WHC-SD-WM-ER-124
Revision 1

The 242-A Evaporator/ Crystallizer Tank System Integrity Assessment Report

1. ECN 608025

Document: WHC-SD-WM-ER-124, Rev. 0, "The 242-A Evaporator/Crystallizer Tank System Integrity Assessment Report"

Figure 18. Pump Room Sump Schematic (Evaporator Building floor drains to the sump via 1 1/2 - 3 in. drain lines and a 10 in. overflow line flows by gravity to the AW-102 Feed Tank. The sump is 5 ft x 5 ft x 6 ft deep).

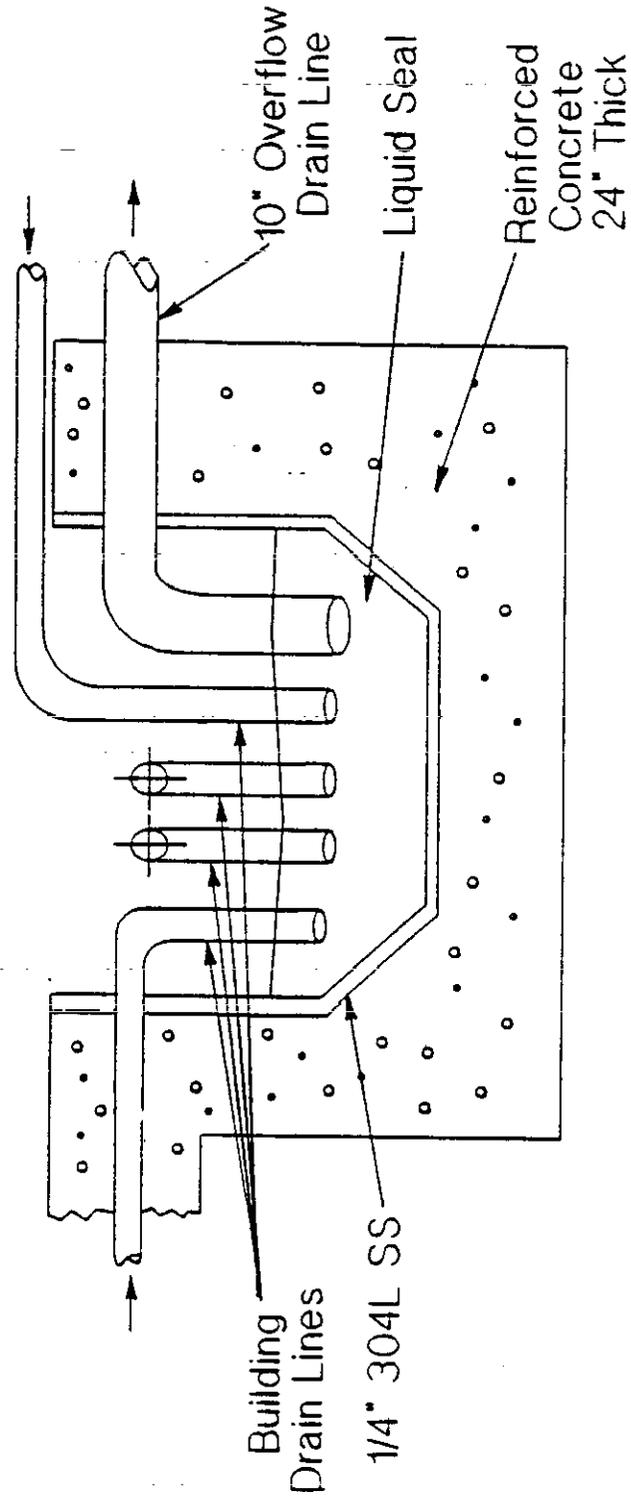
The pump room sump may not comply with WAC 173-303-640(4) requirements for secondary containment.

The pump room sump is alarmed with weight factor (differential pressure) level indication for leak detection and liquid in the sump can be jetted to a double shell tank farm in the event of a leak in the Evaporator/Crystallizer system. However, the liquid seal maintained between the Evaporator/Crystallizer and the feed tank in the pump room sump is assumed to be contaminated with dangerous waste(s). A 0.25 in (0.63 cm) SS liner inserted in 24 in (61 cm) of concrete provides a single boundary containment of this liquid.

~~The pump room sump may not comply with WAC 173-303-640(4) requirements for secondary containment.~~

CORRECTIVE ACTION: Perform an engineering study to identify options for pump room sump compliance. The study should consider costs and benefits (including ALARA) of system upgrades to include secondary containment for the sump or redesign of the liquid seal versus a formal petition for equivalent secondary containment.

CORRECTIVE ACTION: Perform an engineering study to identify options for pump room sump compliance. The study should consider costs and benefits (including ALARA) of system upgrades to include secondary containment for the sump or redesign of the liquid seal versus a formal petition for equivalent secondary containment.
